1966 Corvette: Service Bulletin: Automatic Choke Malfunction

Subject: Automatic Choke Malfunction

Source: Chevrolet Technical Service Bulletin

Bulletin No: TSB #66-6, DR #66-6

FIG. I - CHOKE THERMOSTAT ASSEMBLY - 283 V-8

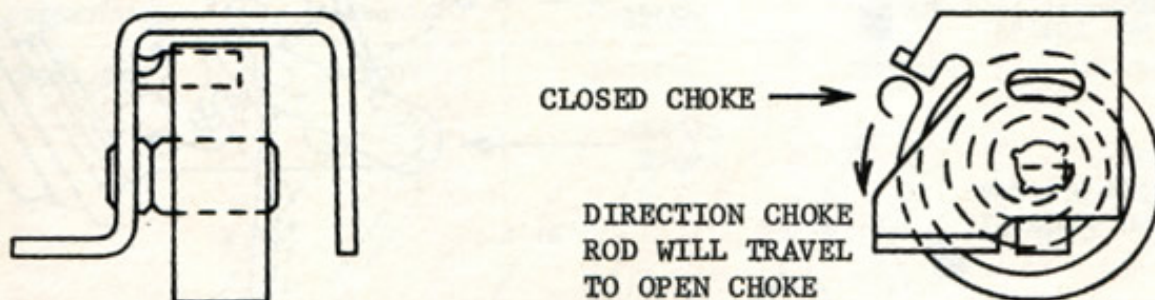
NOTE: Choke thermostat assemblies, although similar in appearance, are not interchangeable. Check bracket design as shown in Figures I, II and III and the coil spring identification number shown on chart (Number stamped in coil, not number in ink). Choke coil springs are indexed to bracket and must not be interchanged or repositioned.

FIG. IV - ROCHESTER 4MV (QUADRA JET) VACUUM BREAK ASSEMBLY

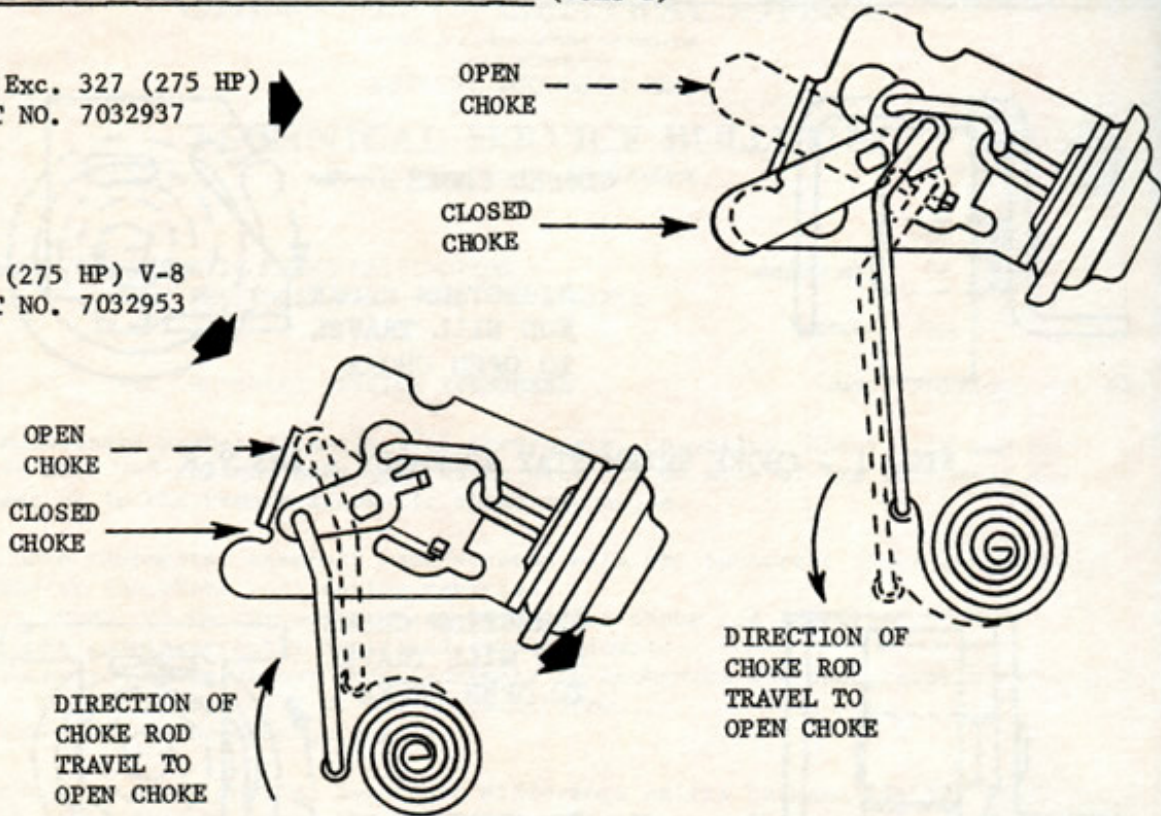
1. Choke thermostat assembly manufactured with the incorrect choke coil spring and/or the choke coil spring reversed.
2. Incorrect choke thermostat assembly and/or choke rod installed.
3. Choke rod incorrectly installed (upside down).
4. Incorrect choke vacuum break assembly on Rochester 4MV carburetor (Quadrajete).
5. Incorrect choke lever on Holley carburetor.
6. Incorrect carburetor on engine.

1. Remove carburetor air horn as outlined on Page 6M-25 of the 1966 Chassis Overhaul Manual.
2. Remove retaining screw from choke vacuum break assembly, then remove assembly.
3. Remove choke lever from float bowl well.
4. Install choke vacuum break assembly as outlined on Page 6M-27, Steps 5, 6, and 7 of the 1966 Chassis Overhaul Manual.
5. Install carburetor air horn as outlined on Page 6M-29 of the 1966 Chassis Overhaul Manual.
